**RUTH HARDING SCHOOL**  
 MODERNIZATION  
 3201 PICO AVE.  
 FOR  
 BAKERSFIELD CITY SCHOOL DISTRICT  
 BAKERSFIELD, KERN COUNTY, CALIFORNIA

**ADDENDUM #01**  
**RUTH HARDING SCHOOL**  
 MODERNIZATION  
 BAKERSFIELD CITY SCHOOL DISTRICT  
 BAKERSFIELD, CALIFORNIA

**REFLECTED CEILING PLAN**

**REFLECTED CEILING PLAN WING'S "500" AND "600"**

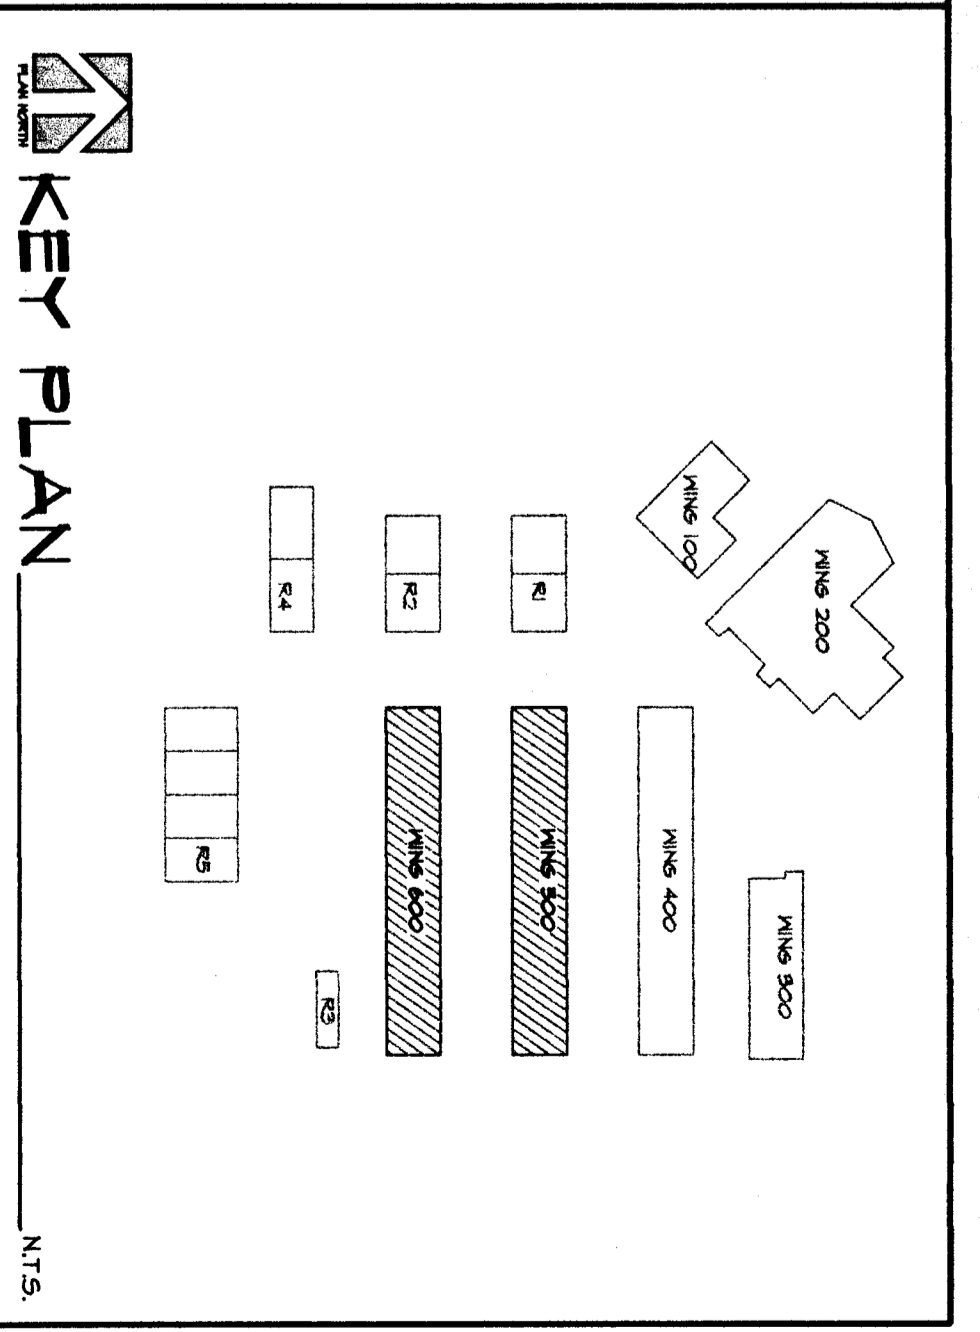
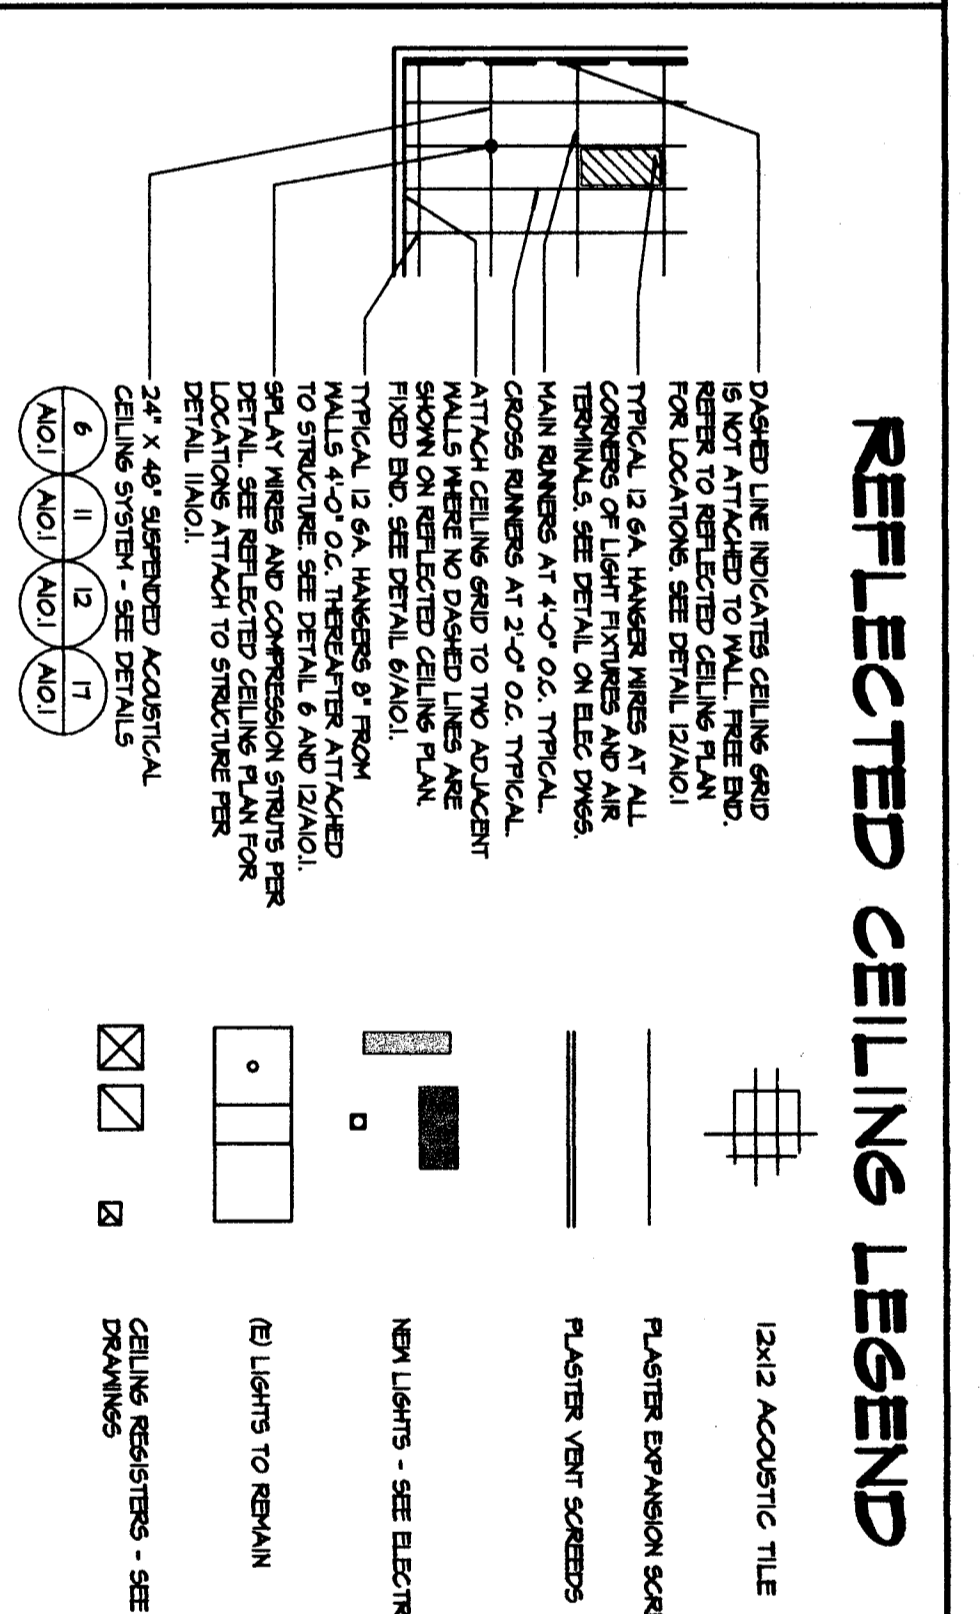
**NOTE:**  
 REMOVE EXISTING ACROUSTIC TILE AND REPLACE WITH 24 ACROUSTIC TILE TO MATCH EXISTING.  
 REMOVE EXISTING ACROUSTIC TILE AND REPLACE WITH 36 ACROUSTIC TILE TO MATCH EXISTING.  
 (E) CEM PLASTER SOFFIT TO REMAIN.
